2006 Throttle Body and Throttle Position Sensor Production Change

Purpose

Figure 1. Orange Dots Indicating New Throttle Position Sensor

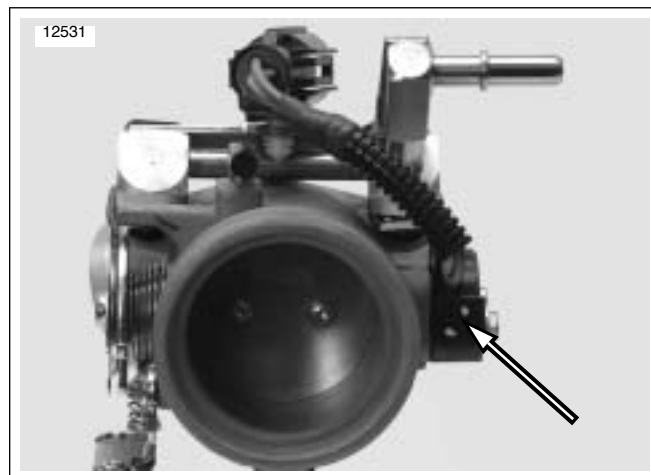
Throttle position sensors are not interchangeable before and after production change. There are two methods to identify the new style TPS. The new TPS can be identified by either one or two orange dots on the top of the sensor. see [Figure 1](#). and supplier Julian date code [Table 1](#).

Figure 2. Julian Date Code

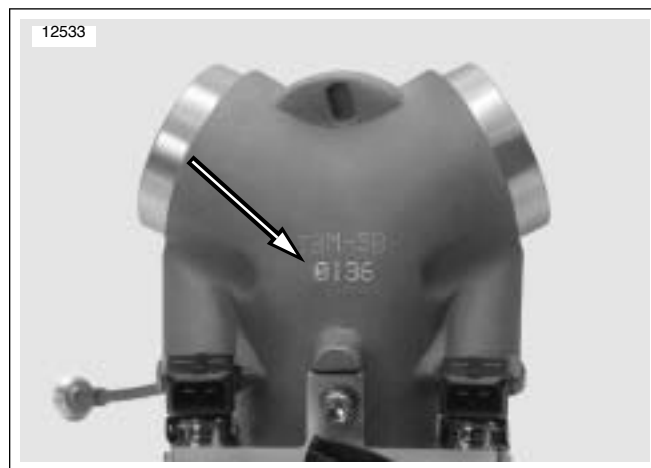
See [Figure 2](#). The supplier Julian date code is not the Buell implementation date of new style throttle body and throttle position sensor. Refer to [Table 1](#). for correct information on implementation dates. **All new style throttle body assemblies are marked with a four character supplier Julian date code beginning with 0136 and higher.**

Figure 3. New Style Throttle Body and Throttle Position Sensor

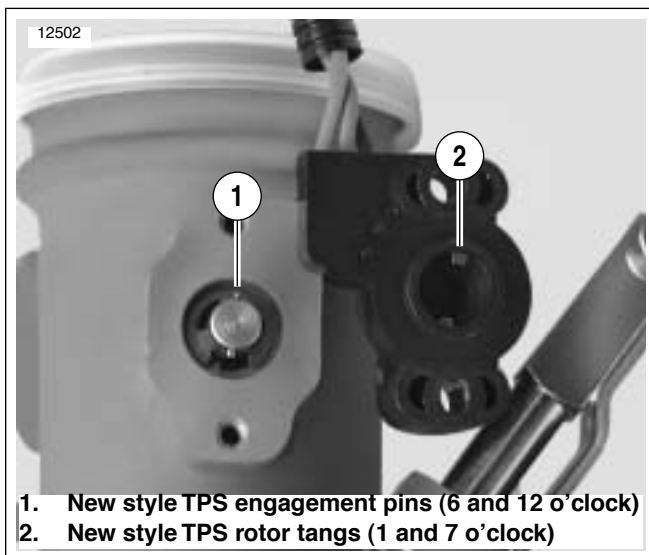
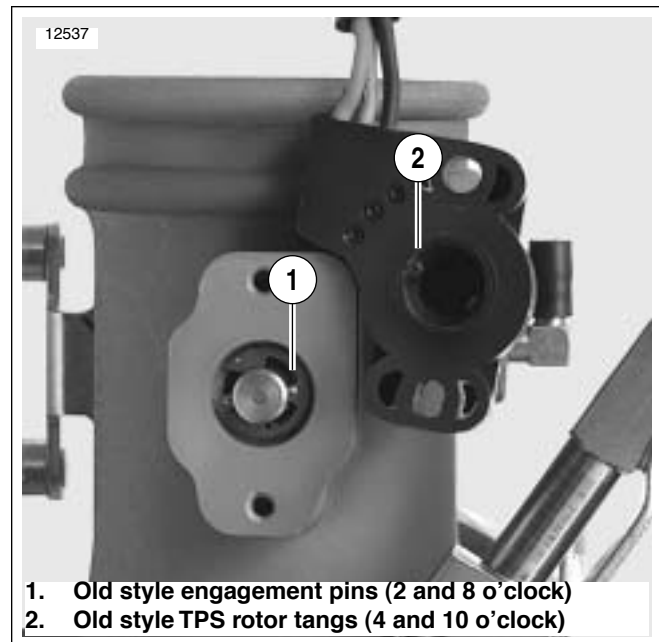
Ensure that proper orientation is followed when replacing TPS. See Figure 3. and Figure 4.

See Figure 3. The new throttle shaft TPS engagement pins are oriented at the 6 and 12 o'clock positions. The new TPS rotor tangs are at the 1 and 7 o'clock positions.

See Figure 4. The old throttle shaft TPS engagement pins are oriented at the 2 and 8 o'clock positions. The old TPS rotor tangs are at the 4 and 10 o'clock positions when viewed disassembled.
